April 28, 2014
Via e-mail & 1st Class Mail

RE: FEMA Flood Map Revisions
Bay Side V-Zones
Borough of Mantoloking, Ocean County

Hatch Mott MacDonald (HMM) is submitting this letter on behalf of the Borough of Mantoloking in response to FEMA's letter dated March 28, 2014, in which FEMA invited comments on the Preliminary FIRM and FIS report. Our comments include: follow-up of previously submitted comments regarding probability and wind direction and wave height analysis (addressed in FEMA's February 24, 2014 letter); responses to requests for additional information contained in FEMA's February 24, 2014 letter; elevation information obtained by a Professional Land Surveyor along the bayside transects and recommendations on using this supplemental information to delineate more accurate flood zones; and additional concerns prepared following a detailed review of the Preliminary FIRM and FIS.

Figure 1 Expanded fetch array for Transect 4460

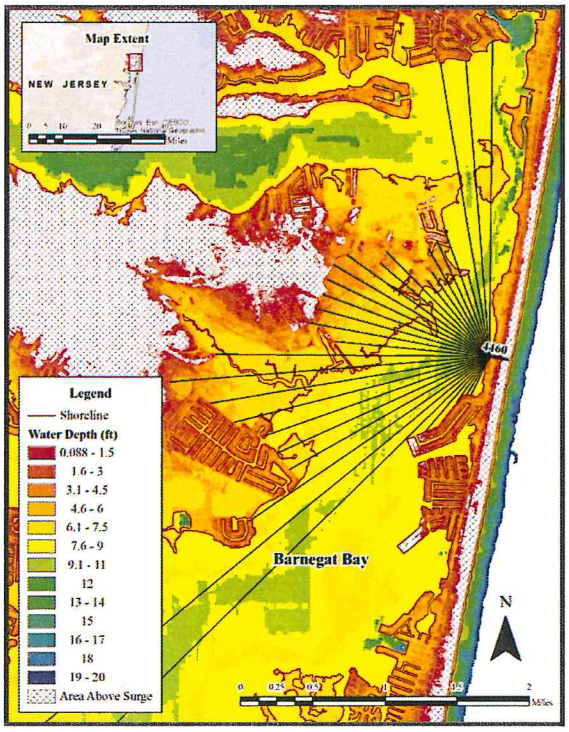
Please use a larger fetch array or provide justification for why the fetch array is limited to a 20 degree sector. It's typical to use a much larger sector (as large as 170 degrees).

The 20° fetch sector was deemed appropriate, based on the WHAFIS underlying assumption that the wind blows from the same direction as the transect orientation. Nonetheless, a wider fetch array was considered in ACES to test the sensitivity of the results to this assumption. Figure 1 shows a 160° fetch array for Transect 4460 and Table 1 shows the original and new results.

The results for the expanded fetch array show a slight increase in the ACES-calculated weighted fetch length and in the predicted height and period of the waves. The relatively small increase is likely because the wind direction specified in ACES is aligned with the transect orientation, consistent with the WHAFIS framework. Therefore, the amplification of the fetch array does not have a significant impact on the predicted wave height.

Preliminary FIRM Review
Borough of Mantoloking
Map No. 34029C0216G

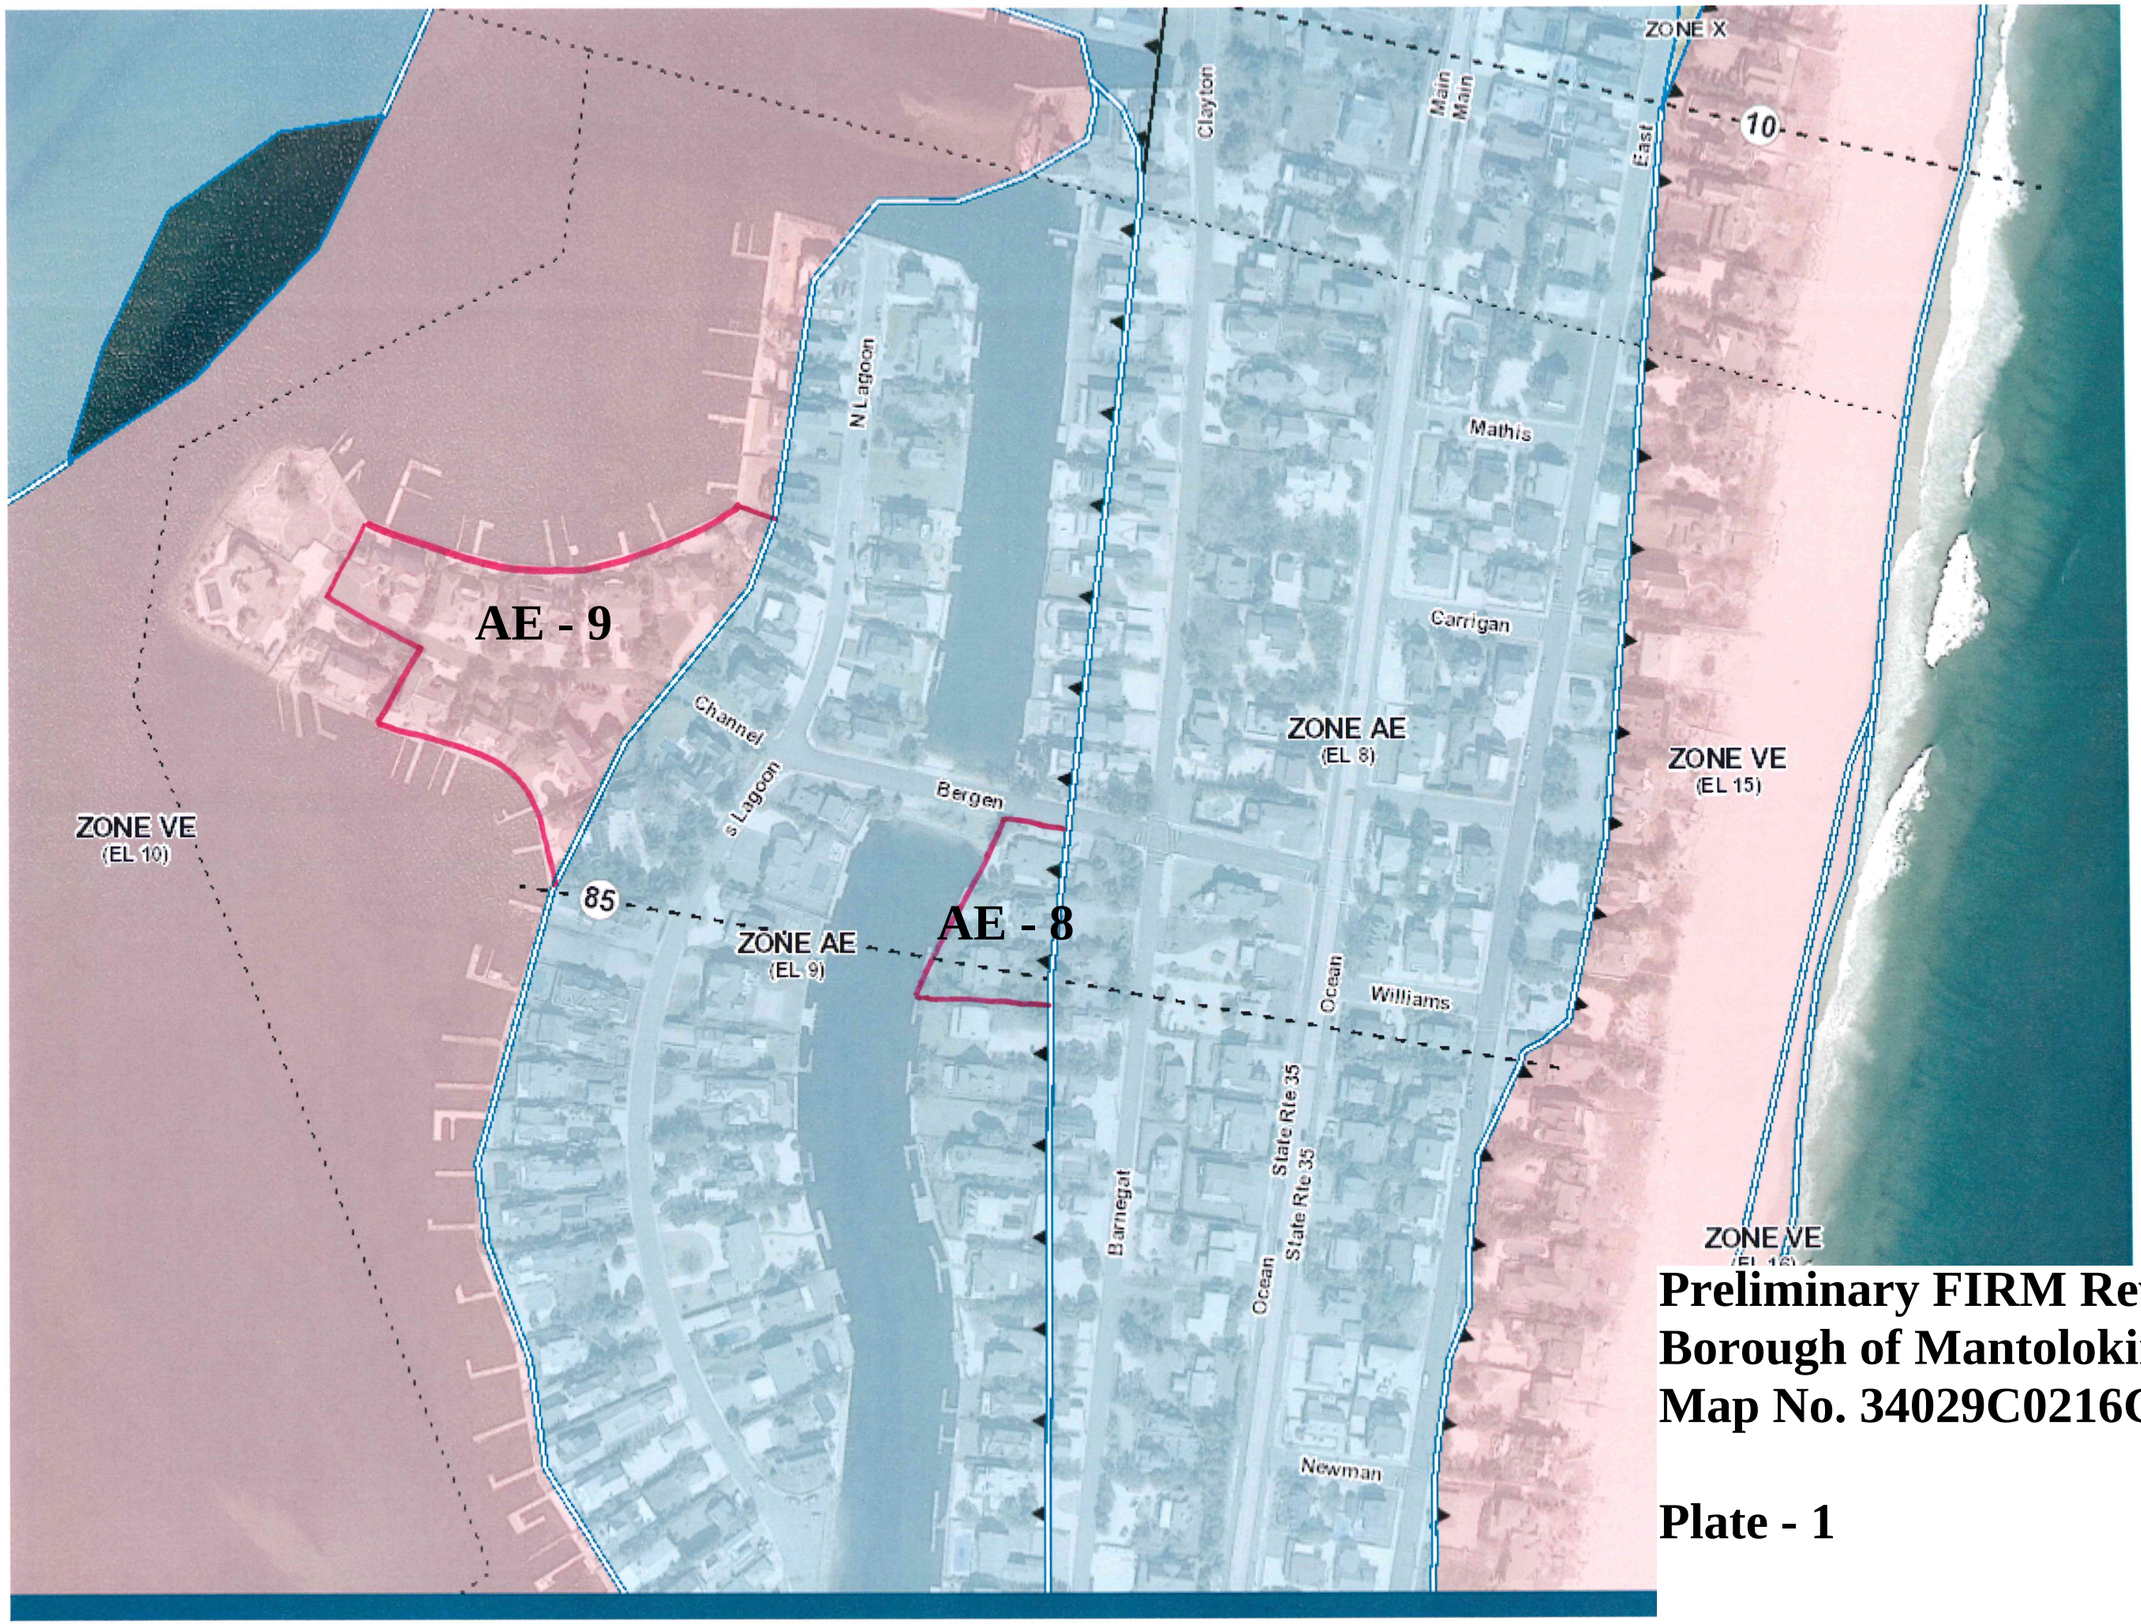
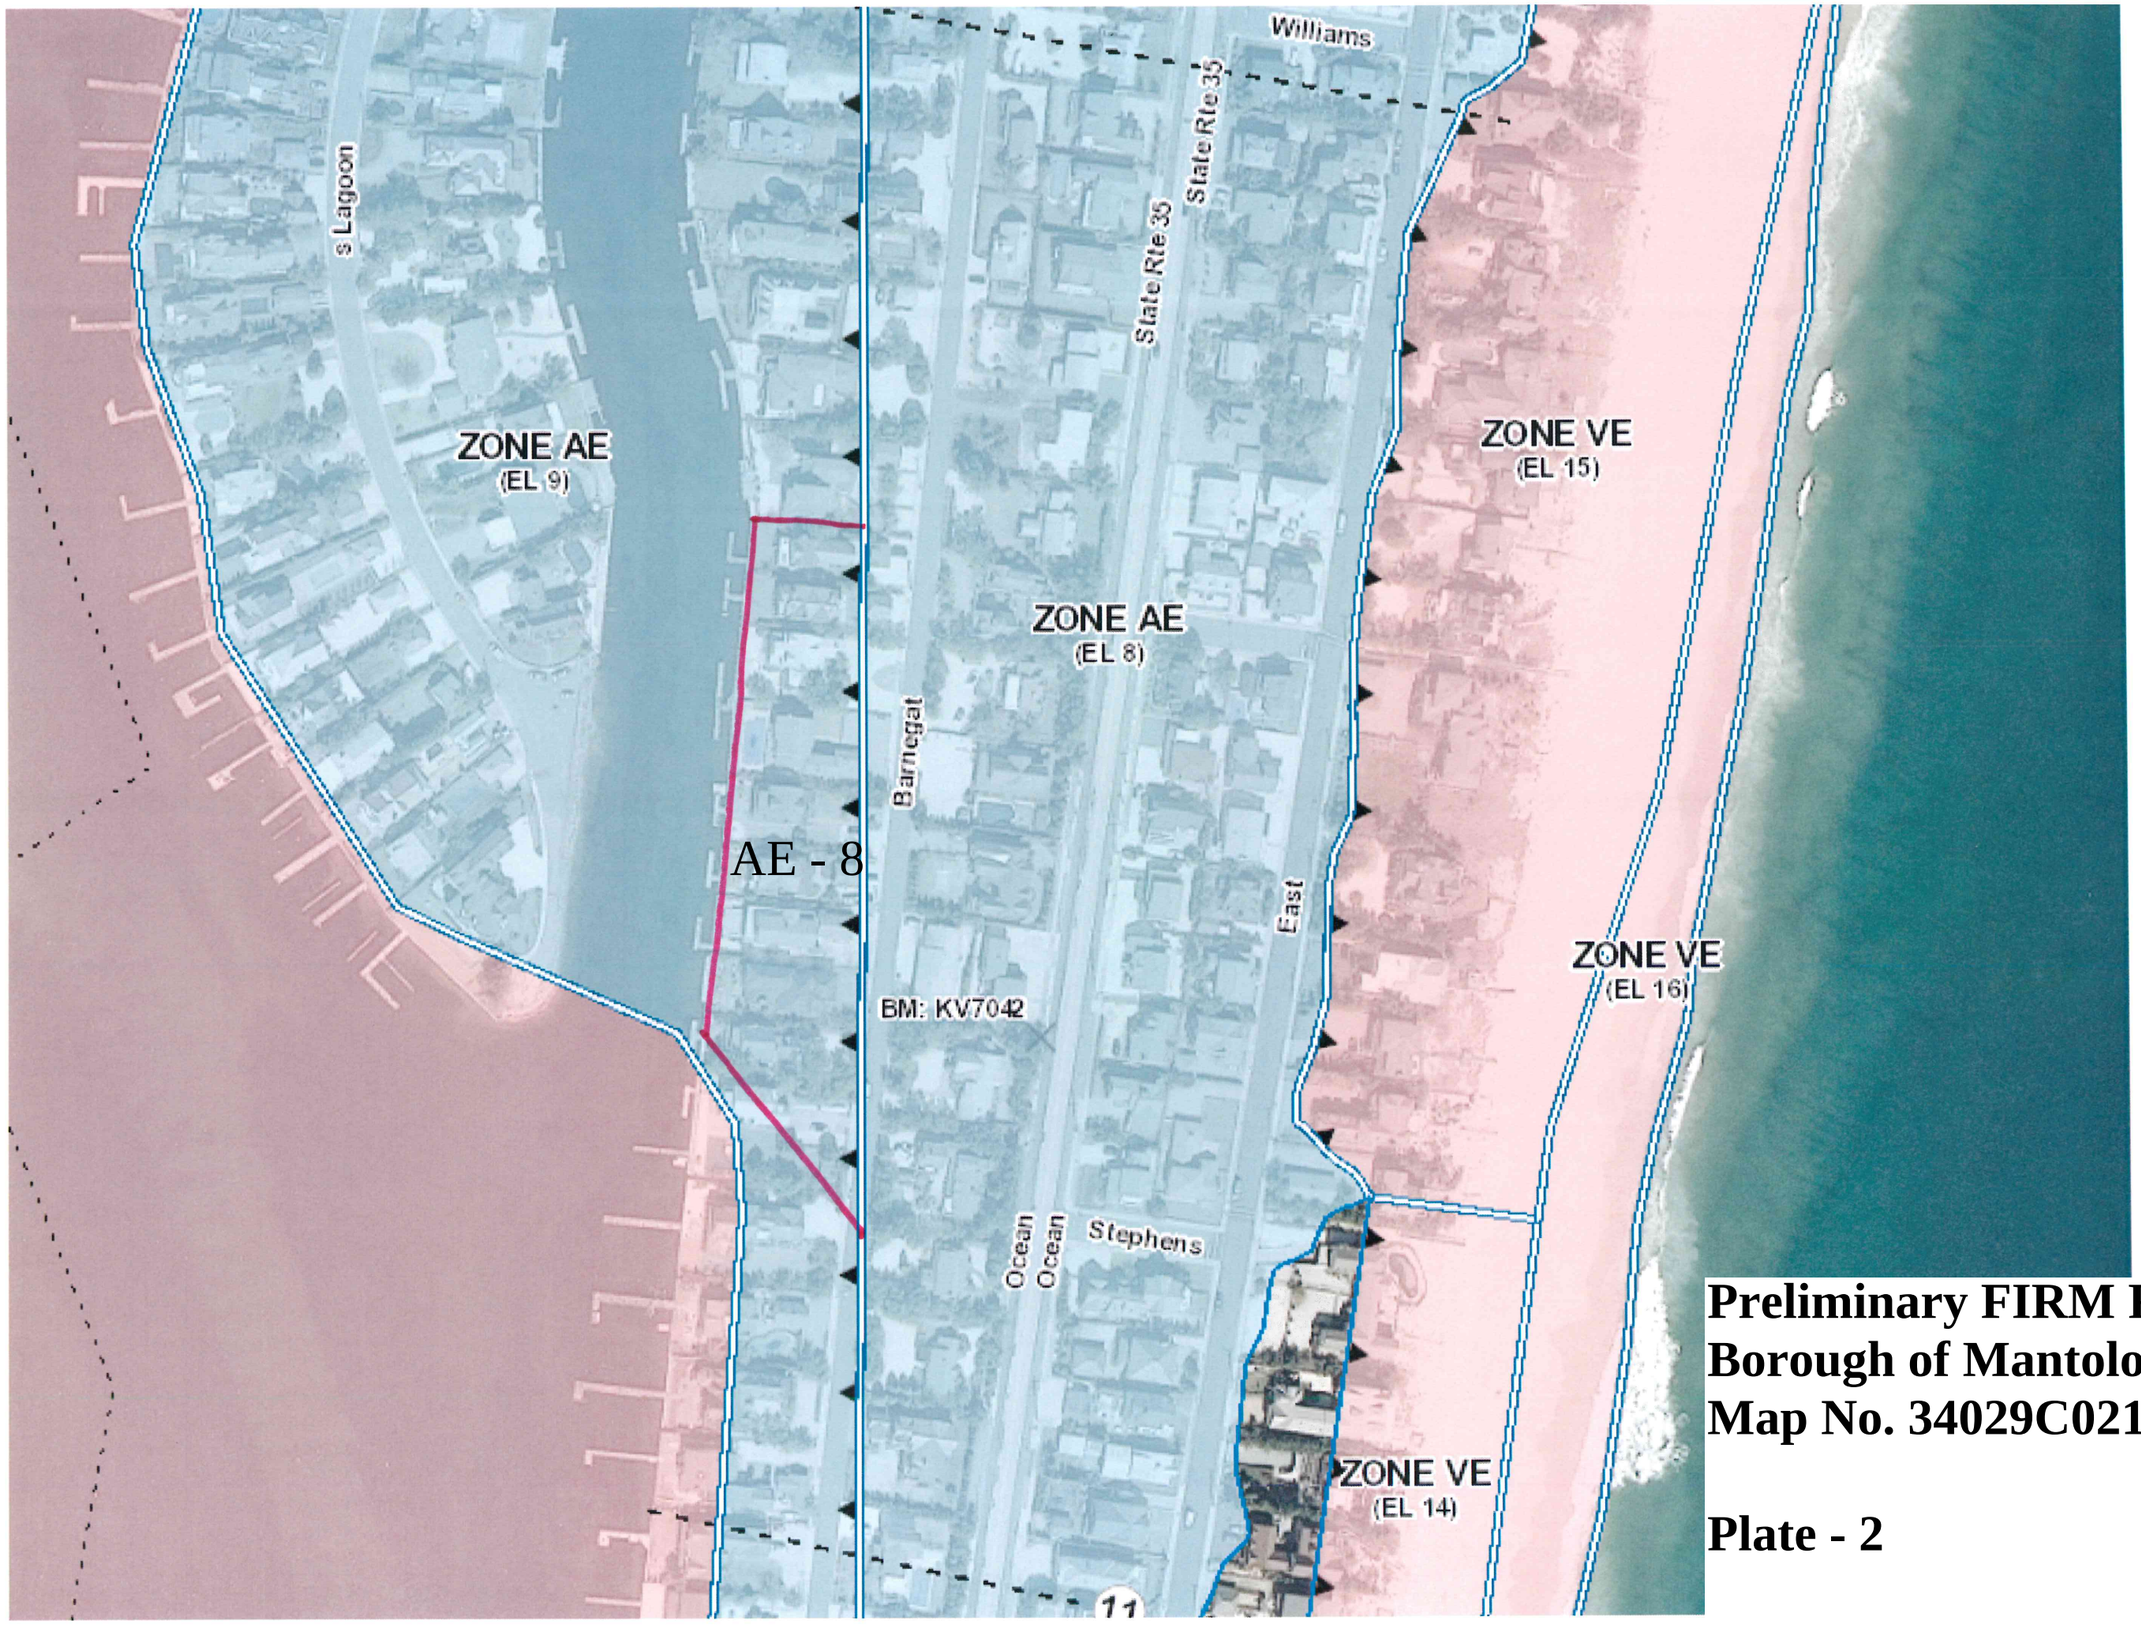
- As indicated in the FIS and mentioned in Section 3.0 of this report, transect elevation data is used to determine the expected height of the wave crests and run-up utilized by WHAFIS modeling to determine the FIRM's flood boundary limits. As these transects are quiet a distance apart, it is mentioned that elevations were interpolated using topographic maps, land-use and land-cover data and engineering judgment to determine the extent of the flood zones. HMM has reviewed these determinations of the proposed zones and offers at least three (3) distinct proposed revisions per the attached Plates (1-3), where significant grade changes exist which were not captured in the flood mapping. Please note that the suggested revisions shown on Plates 1-3 are meant to serve as examples of how the flood zones may be redrawn based on the additional provided survey information along the transects as well as on the high-accuracy topographic mapping, which we have attached for your use and

consideration. They are not meant to represent a precise delineation of those zones, but an outcome that we would expect as a result of more detailed analysis to be performed by FEMA, utilizing underlying data in your possession. We can also provide the detailed topographic data in a CAD file, in NAD83 and NAVD88 datums, for your use.
